BCA ASSESSMENT REPORT

PORT BOTANY INDUSTRIAL ESTATE

PREPARED FOR:
GOODMAN PROPERTY SERVICES
(AUST) PTY LTD

Revision 02

Figure 1 – Areas of Non-Compliant Perimeter Vehicular Access per BCA C2.4.

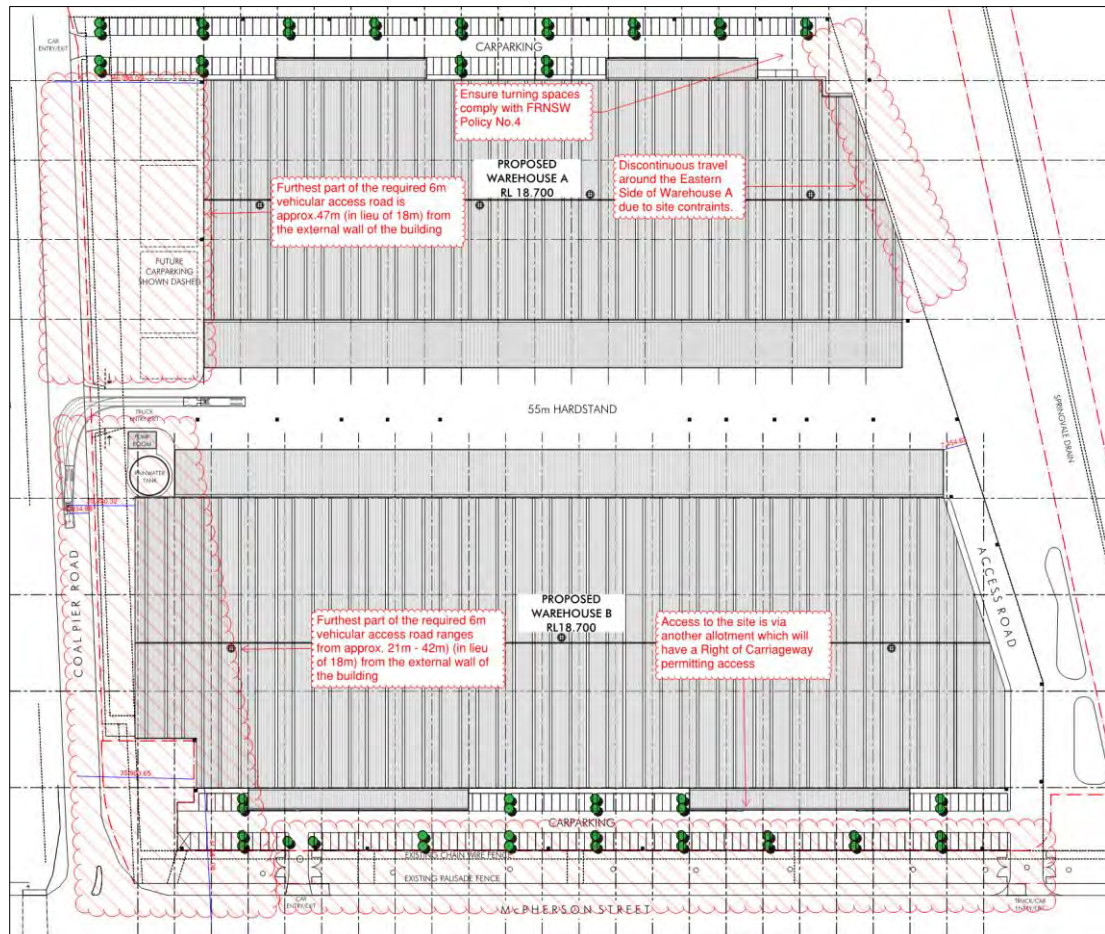
Alternative Solution: The following non-compliance issues are required to be addressed as an Alternative Solution by the Fire Safety Engineer - refer to the numbered points below and the diagram over page for details of the proposed non-compliance issues:

- 1. Vehicular Access will only be provided around three (3) sides of the building and is therefore discontinuous along the Eastern side due to site constraints associate with the Flood Storage Areas on the site. Suitable turning provisions will however be available along the Southern and Northern sides to facilitate brigade operations.
- 2. Additionally, the Western side will have the furthest part of the required 6m access road located at distances greater than 18m from the external walls of the building (approx.47m).

- 3. Vehicular Access will be provided around all four (4) sides of the building however the Western & South-Western side will have the furthest part of the required 6m access road located at distances greater than 18m from the external walls of the building (approx. ranging between 21m and 42m).
- 4. Additionally, access to the site from McPherson Street necessitates brigade vehicles crossing via a separate allotment which will have a Right of Carriageway.

- 5. Access to the site will be controlled access and there will be secured access entry and gates at the main entrance.

Note: The above non-compliance issues are required to be addressed as an Alternative Solution by the Fire Safety Engineer to demonstrate compliance with Performance Requirements CP9.
